SERVICE INFORMATION LETTER

SERVICE INFORMATION LETTER NO. 0189

DATE: February 4, 2019

1. SUBJECT: Magneto Retard Terminal P-Lead Insulator
2. MODEL: F-28C, F-28C-2, F-28C-2R, F-28F, F-28F-R, 280C, 280F, and 280FX
3. EFFECTIVITY: F-28F S/N 832 and prior; 280FX S/N 2158 and prior; any F-28C, F-28C-2, F-28C-2R, F-28F, F-28F-R, 280C, 280F, and 280FX that may have had the P-lead insulator changed in the field
4. BACKGROUND:

Figure 1. Timing index marks extended onto the ring gear

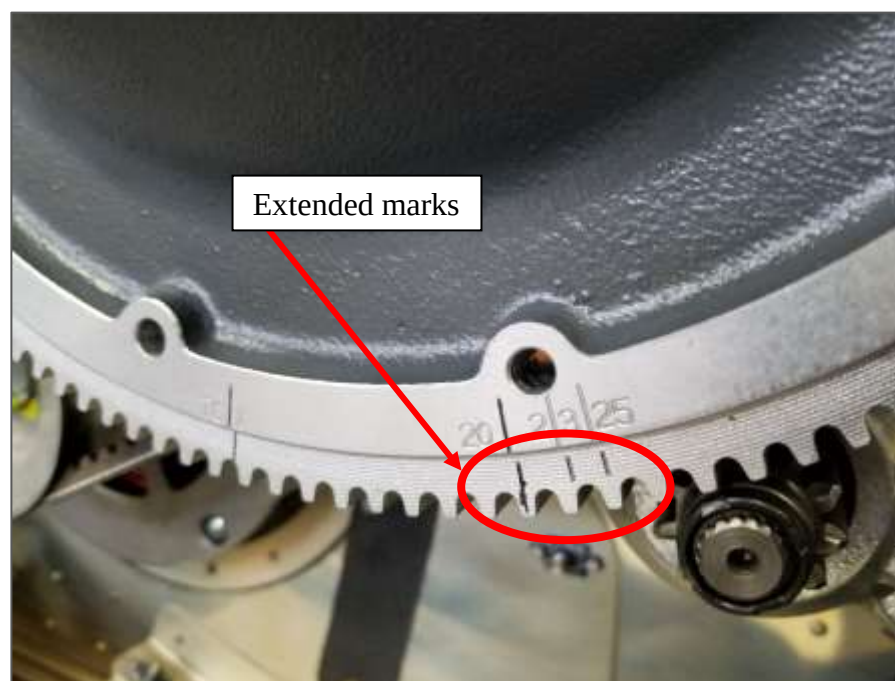
NOTE: **The ignition timing marks are stamped into the starter ring gear support assembly and not actually on the ring gear. To aid in setting the magneto timing, it may be advisable to extend the marks onto the ring gear using a fine Sharpie® or similar marker (Figure 1).**

Figure 2. P/N 10-382812 Rubber Insulator

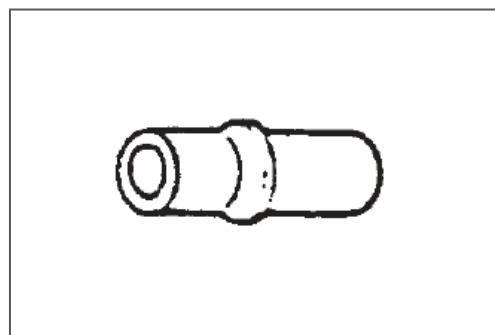
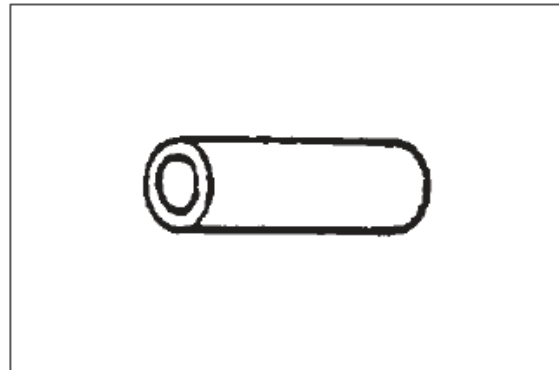
The magneto retard terminal insulator may be either phenolic or soft rubber. The soft rubber insulator is generally used in pressurized magnetos. It forms a tight seal but the compressed insulator may hold the wire insulation and prevent the lead from seating on the terminal and making proper electrical contact. The phenolic insulator will not trap the wire insulation so the lead will make better contact with the terminal. The aircraft with the serial numbers listed above were assembled with a soft rubber insulator (Figure 2). Enstrom recommends checking for this rubber insulator and, if installed, replacing with a phenolic bushing to allow the lead to seat properly.

At the next 100 hr/annual inspection, determine if the P-lead insulator is rubber. If so, replace P/N 10-382812 rubber insulator with P/N 10-157212 (Kit P/N 10-157208) bushing in accordance with paragraph 6.

6.6 Slide the rubber P-lead insulator (P/N 10-382812) (Figure 2) off of the wire and slide the phenolic insulated bushing (P/N 10-157212) (Figure 3) onto the wire.
